STAFF REPORT

Conditional Use (CU-06-16) and Site Plan Review for Tree Felling (SP-16-16) for New Construction of a Skilled Nursing Facility and a Memory Care Building within an existing Senior Care Community (Mennonite Village)

DATE OF REPORT: November 10, 2016

4 SCHEMATIC LANDSCAPE PLAN (CUP)

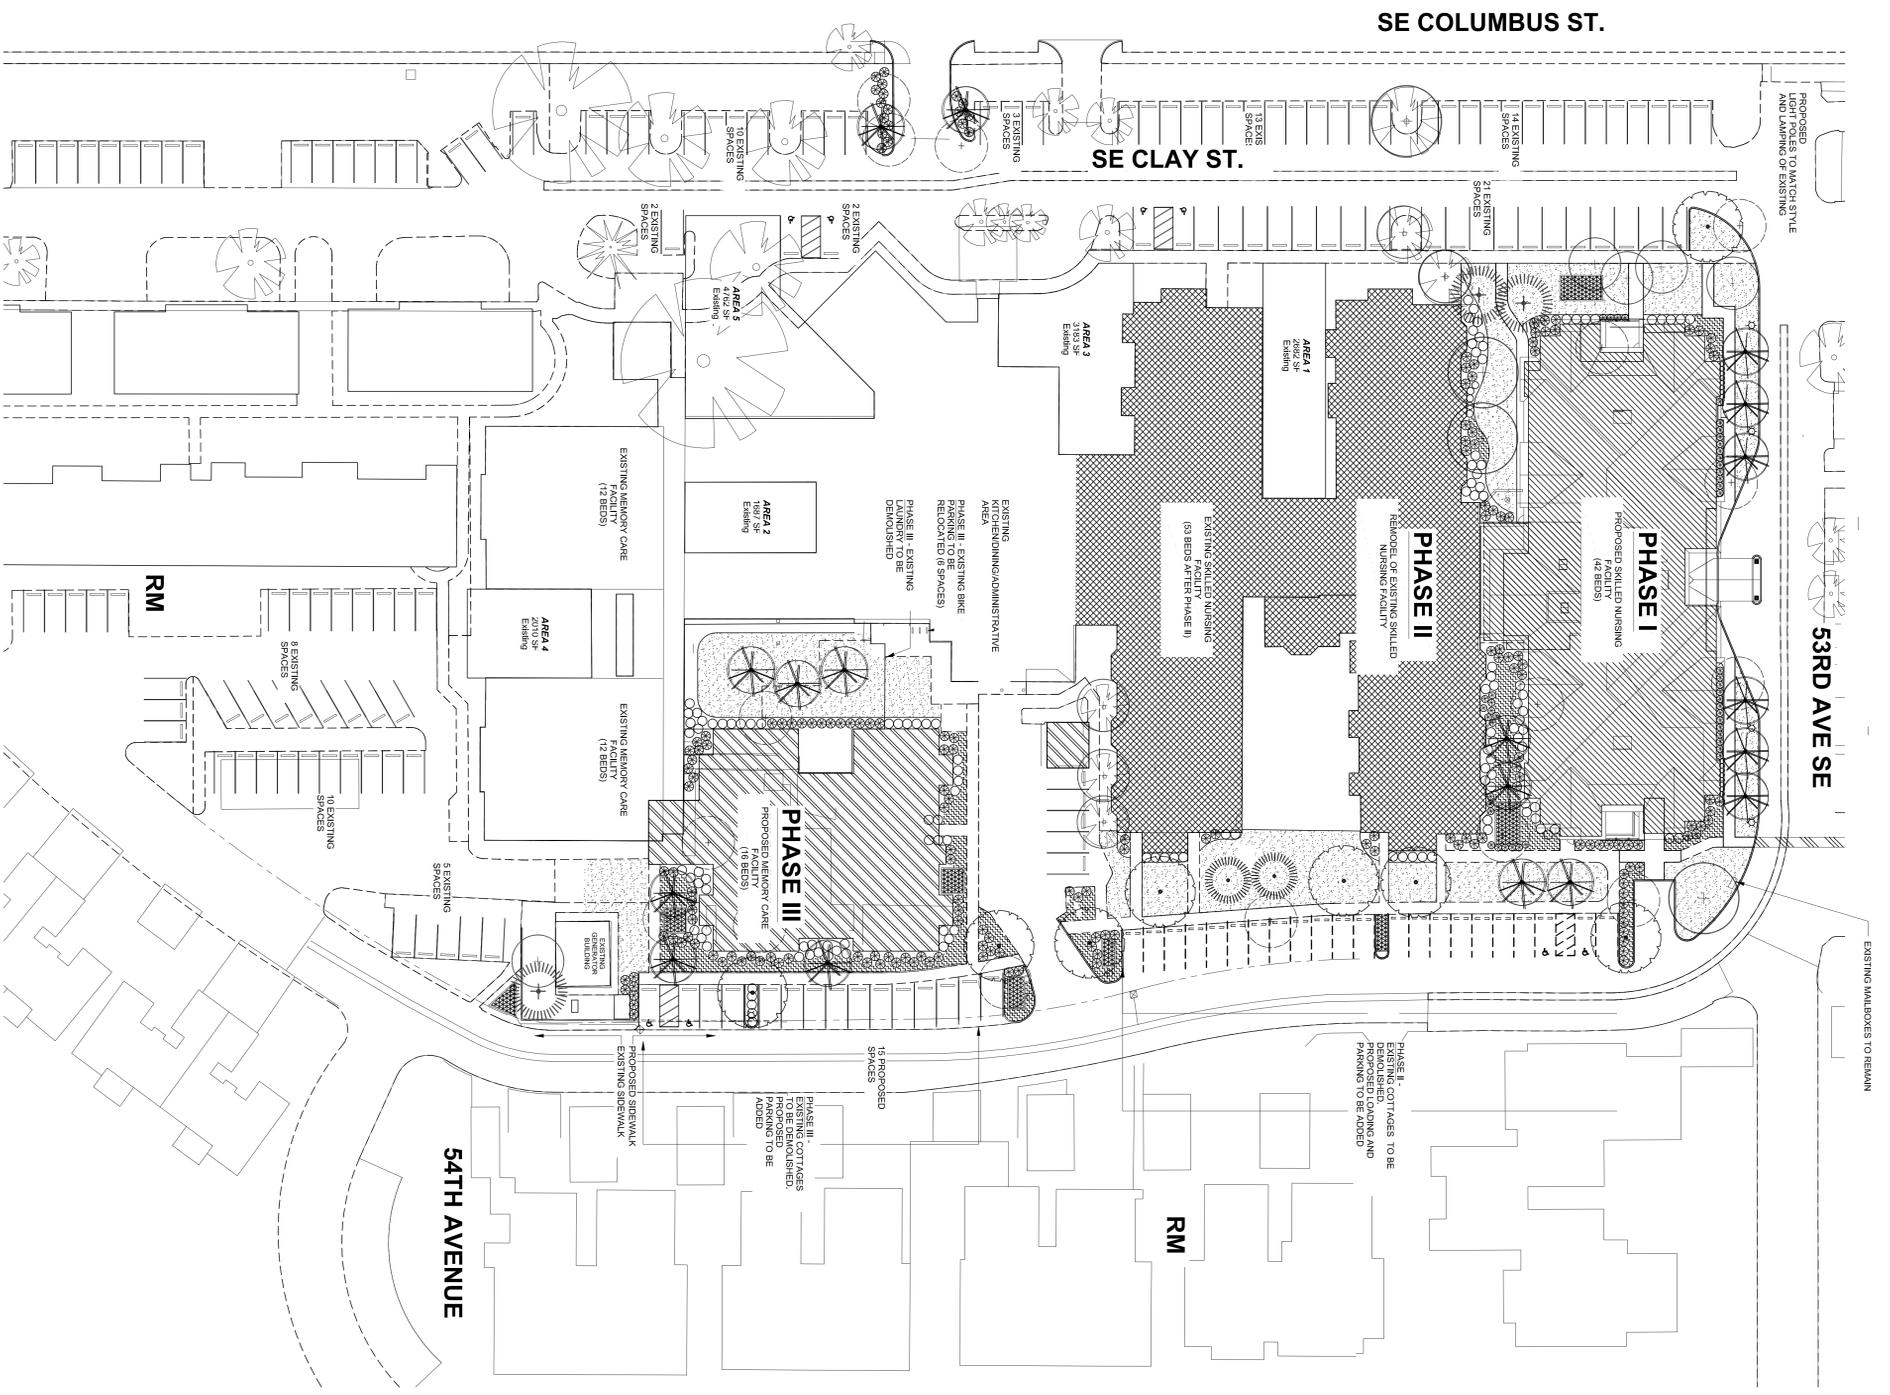
- The Landscape Plan (Sheet L101) does not show existing front yard setback landscaping along the Columbus Street frontage. From aerial photos, it appears that much of the

4 SITE PLAN (CUP)

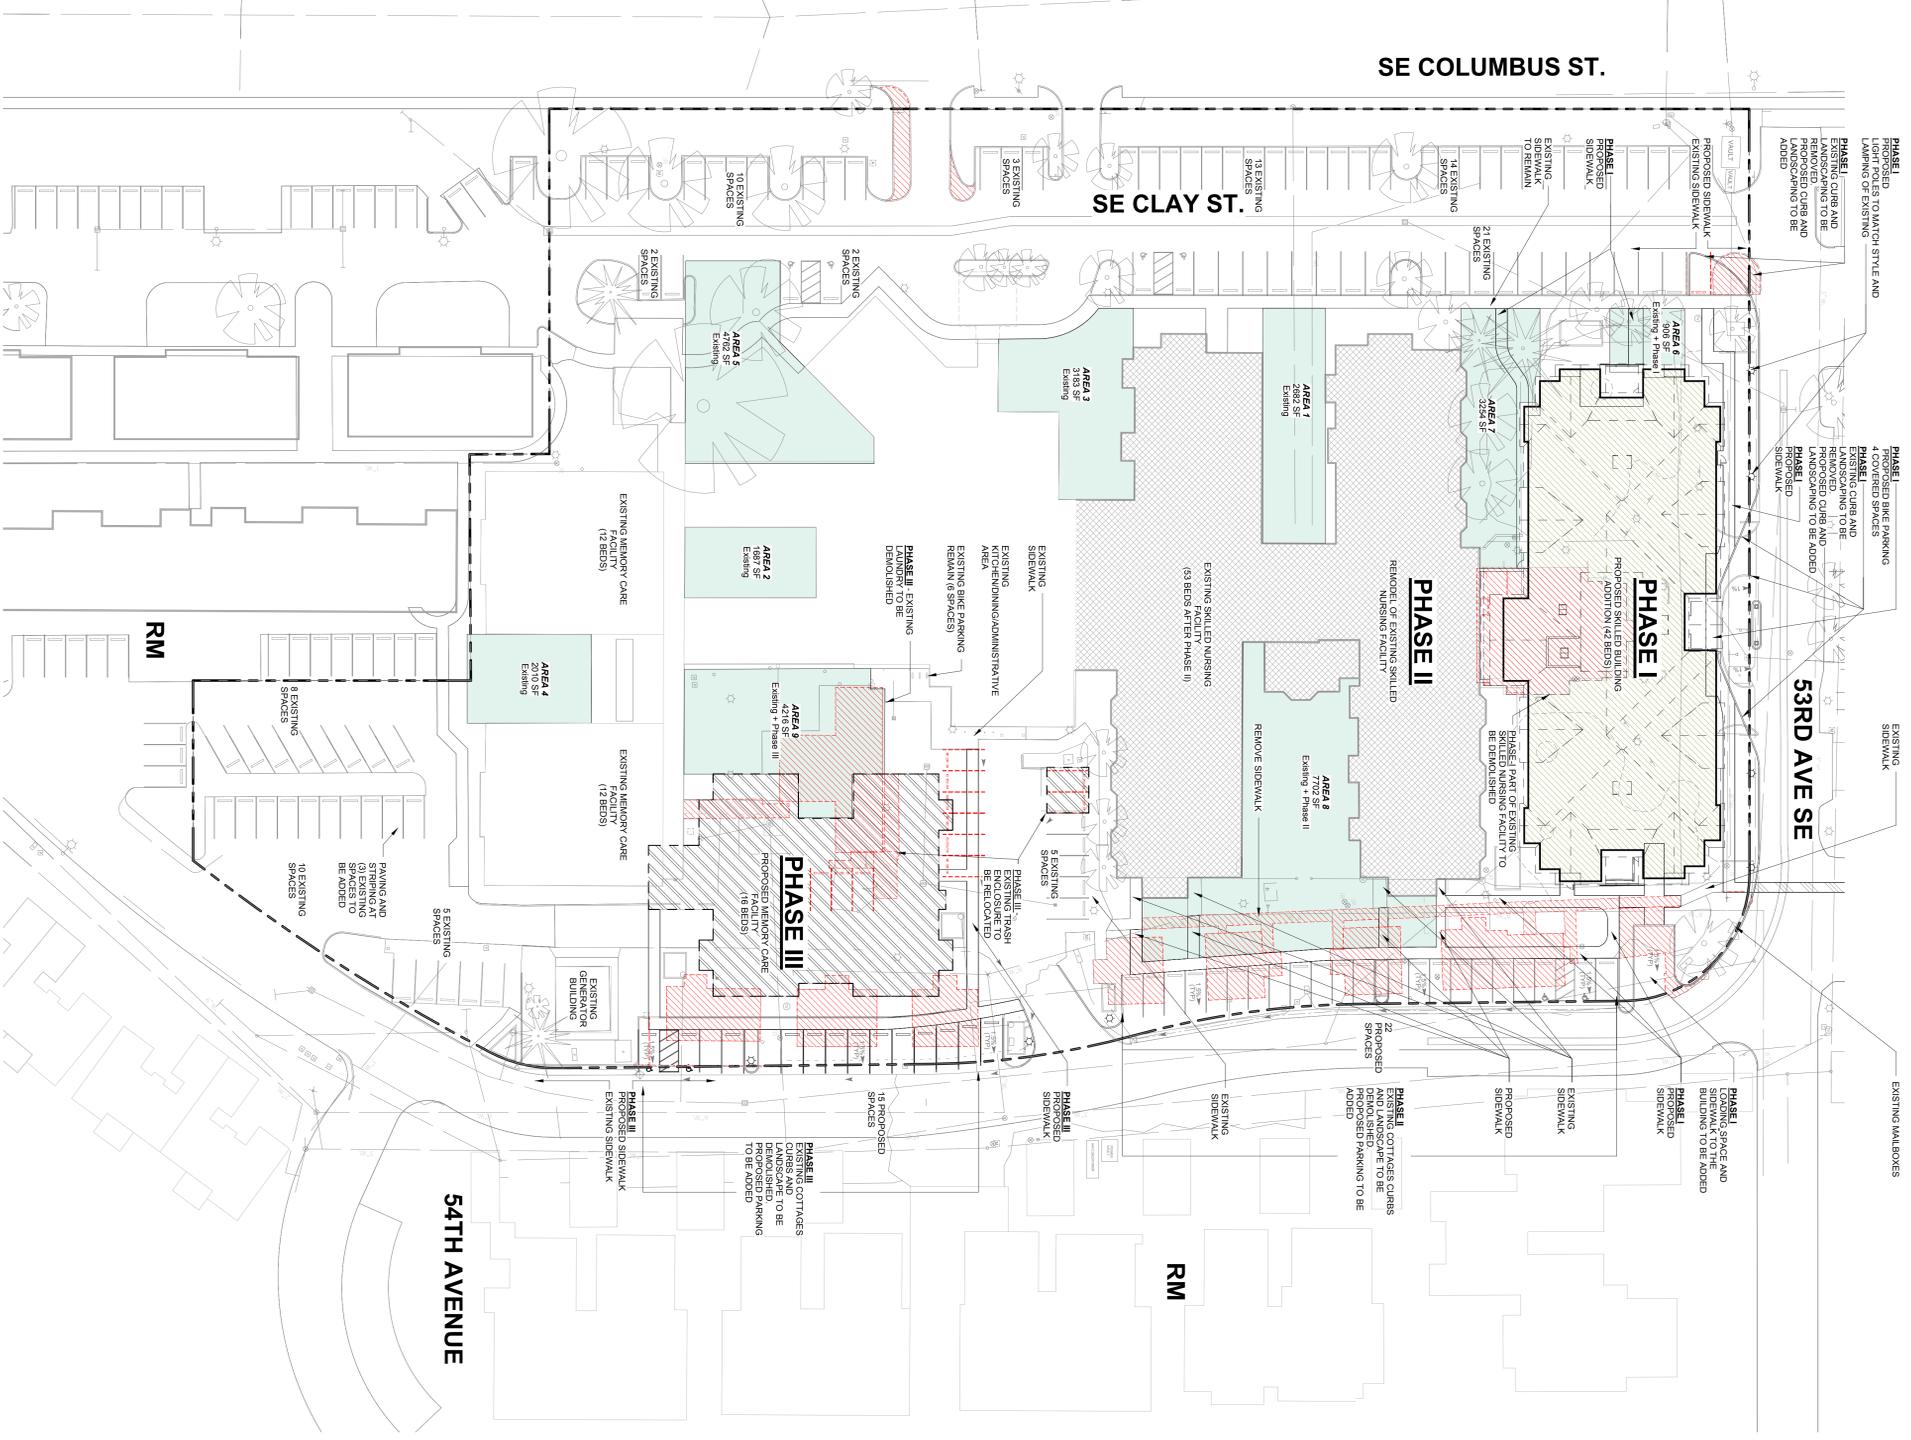
- The three-story skilled nursing facility appears to be about 12.5 feet from the northerly property line adjacent to 53rd Avenue (private). Findings on Page 9 of your submittal state that all proposed structures are set back from the property line a minimum of 15 feet. Please let me know if the building shown on Sheet A002 has roof overhangs that make it appear to be set back less than 15 feet from the property line. Architectural appendages can extend into a front yard setback up to 5 feet, but I just need confirmation of what I'm looking at. **[That line shown adjacent to 53rd Ave is a tax lot line, not a property line, and there are no setback requirements from a tax lot line. The building setback from that tax lot line is approximately 13'-8".]**

SHEET:
A050

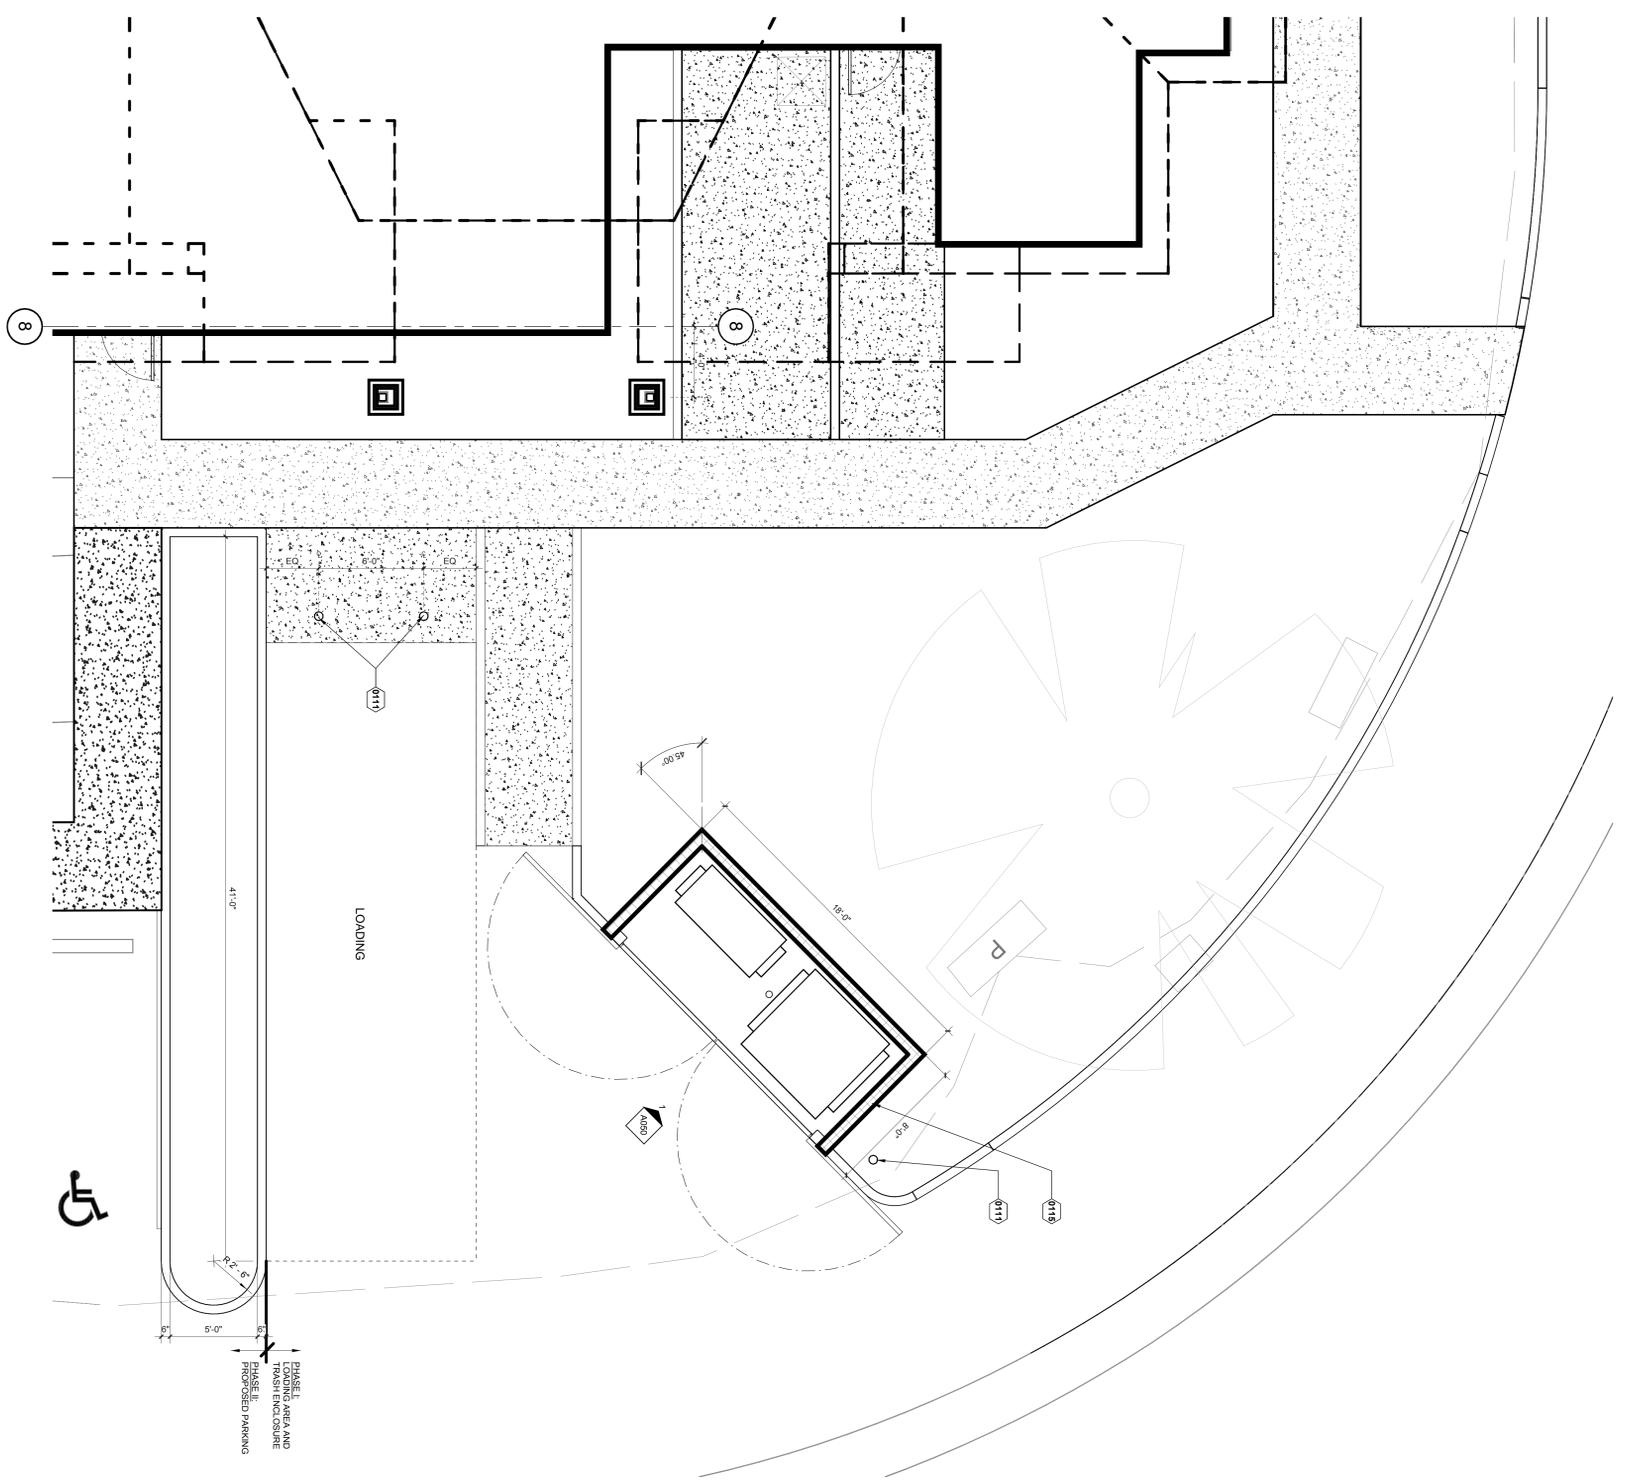
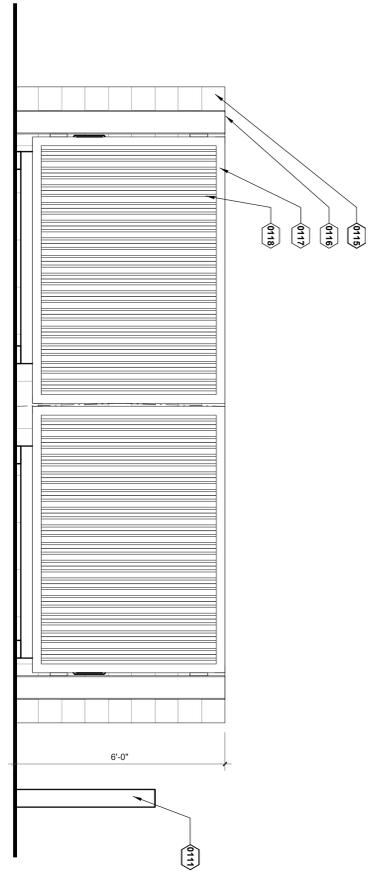
- The method of screening provided on Drawing A050 is adequate, but please confirm the final location where the refuse area will ultimately be placed. [The location of the trash enclosure shown in drawing A050 will be the final location.]
